ADDENDUM NO. 4  
WATER SYSTEM IMPROVEMENTS  
CONTRACT 18-01  
GREENWAY BOULEVARD AND BACK VALLEY ROAD WATER LINE EXTENSIONS  
CONTRACT 18-02  
INDUSTRIAL PARK 500,000 GALLON ELEVATED WATER STORAGE TANK  
DAYTON, TENNESSEE  
WAUFORD PROJECT NO. 4630

Date of Addendum: June 3, 2019

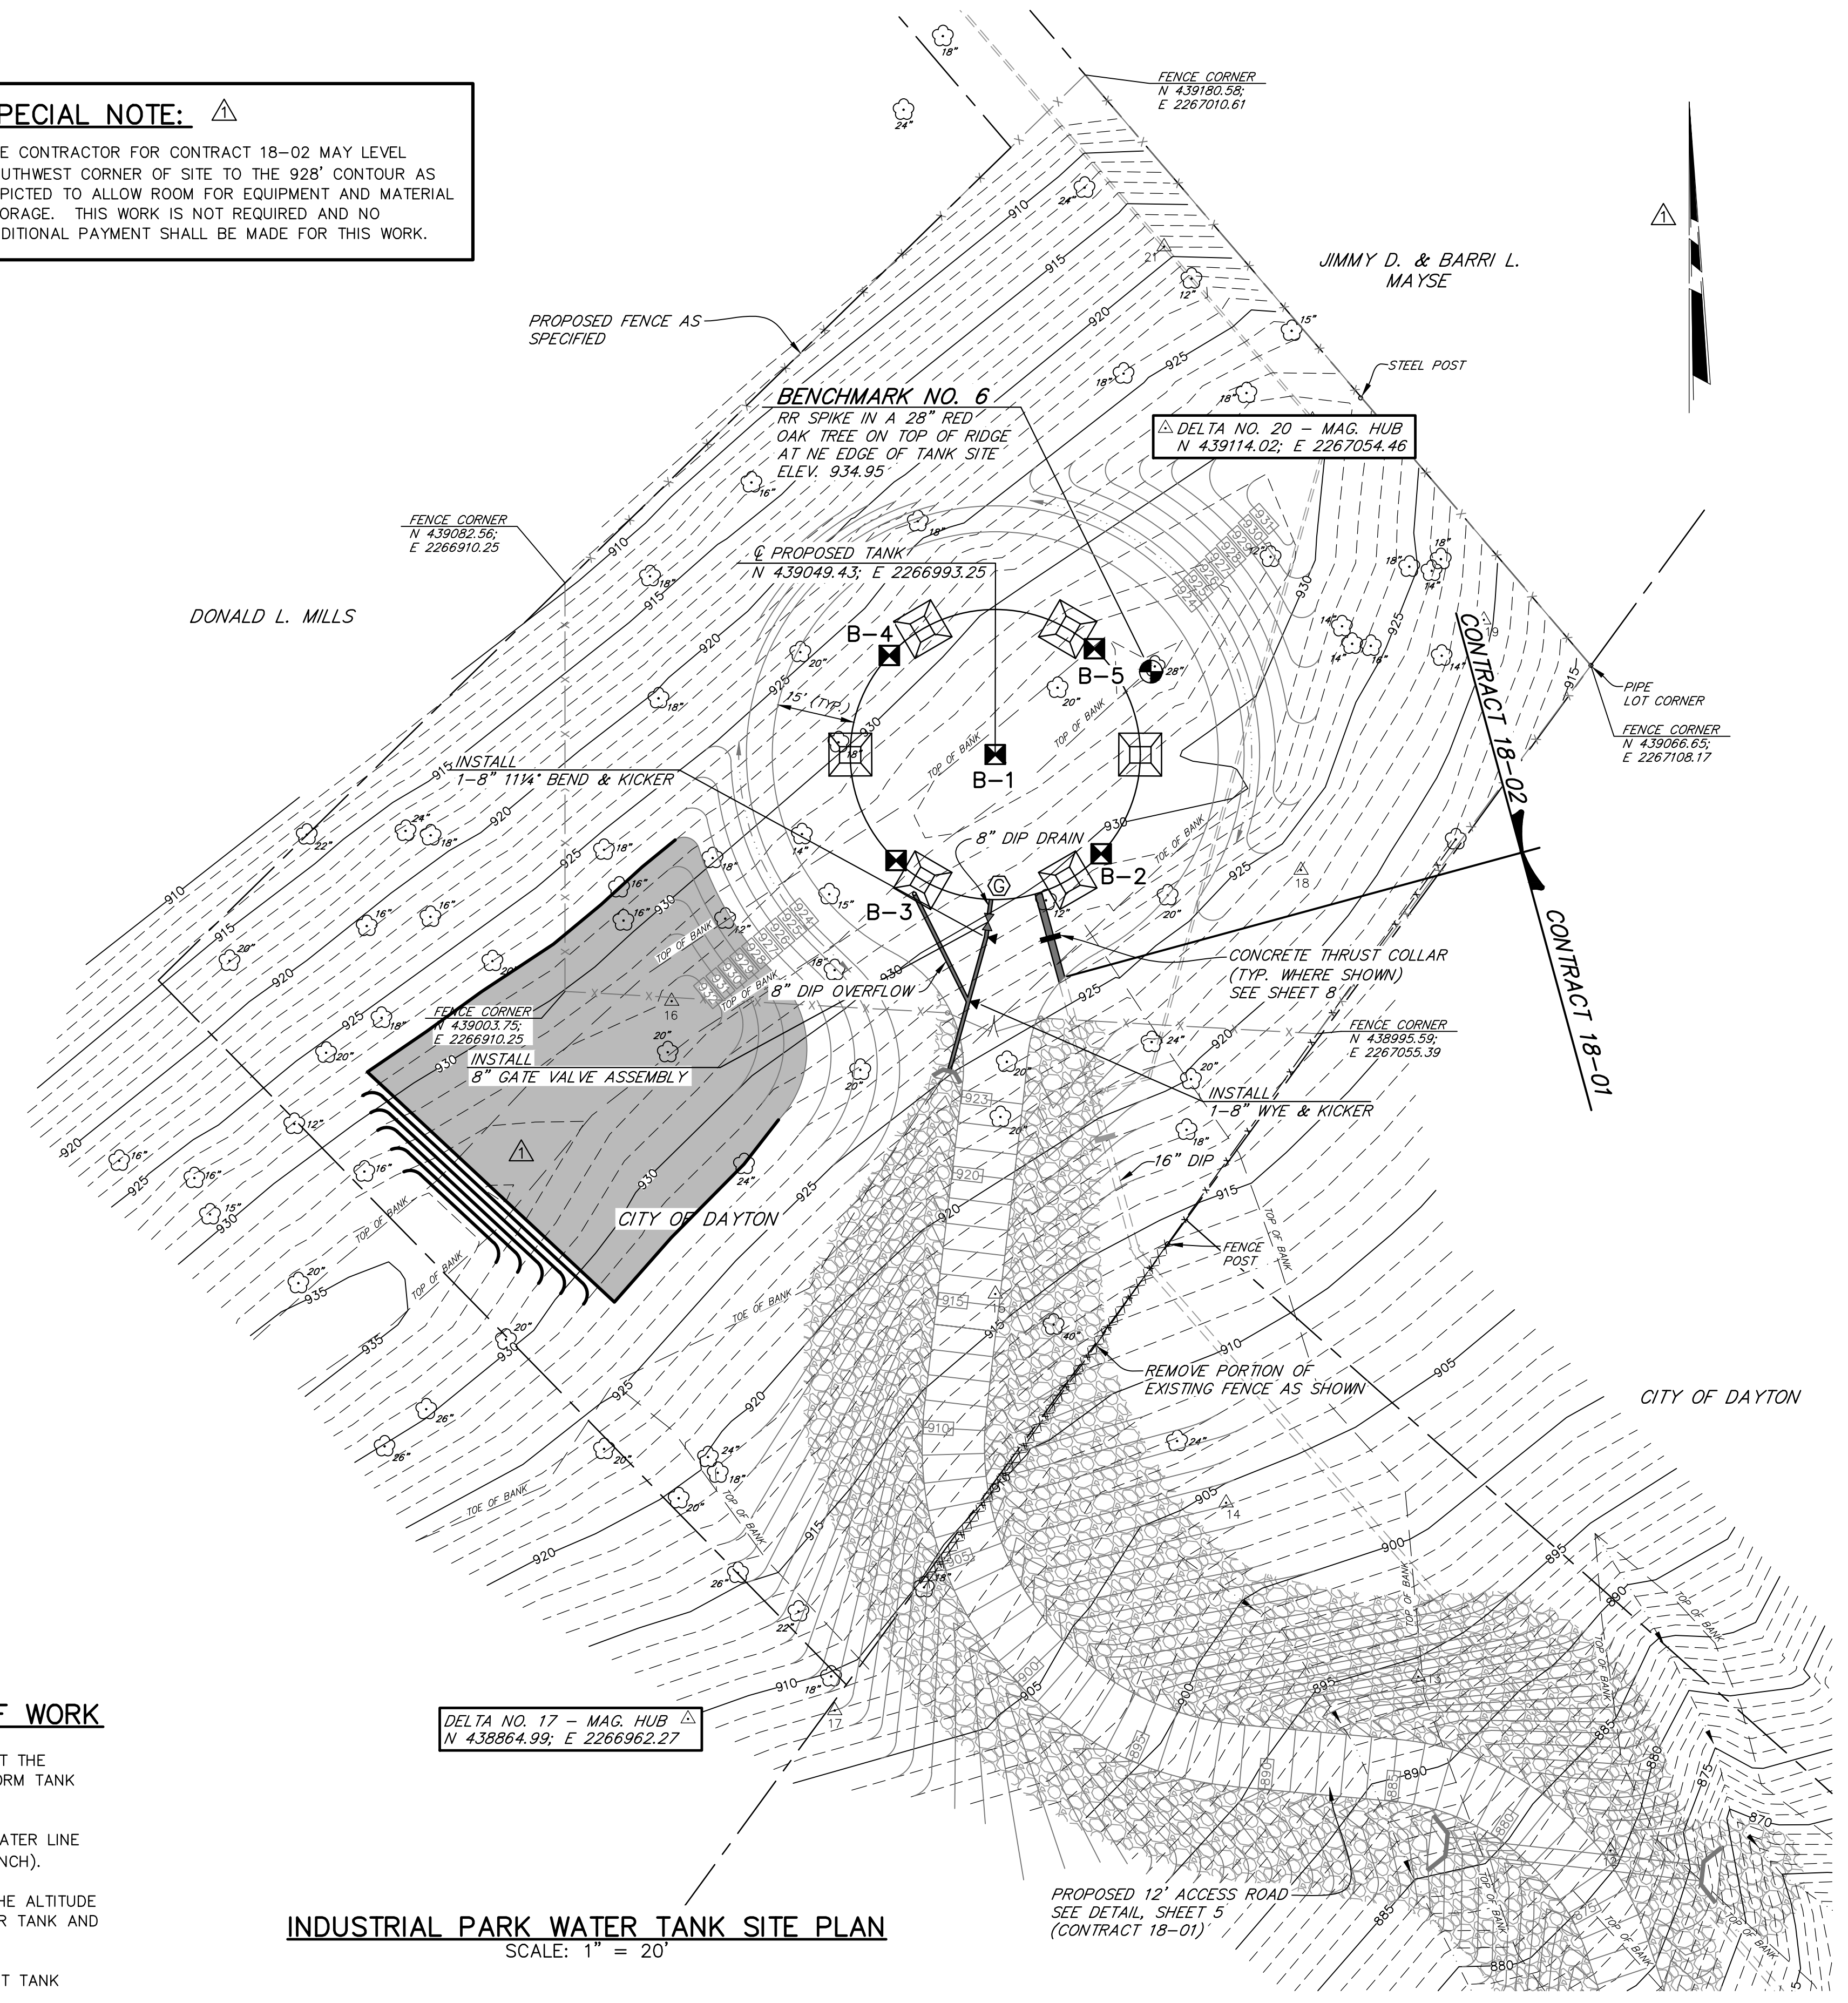
3. Plans, Sheet 9:

Revise as shown on attached Plans, Sheet 9.

**SPECIAL NOTE:** ⚠️  
THE CONTRACTOR FOR CONTRACT 18-02 MAY LEVEL SOUTHWEST CORNER OF SITE TO THE 928' CONTOUR AS DEPICTED TO ALLOW ROOM FOR EQUIPMENT AND MATERIAL STORAGE. THIS WORK IS NOT REQUIRED AND NO ADDITIONAL PAYMENT SHALL BE MADE FOR THIS WORK.
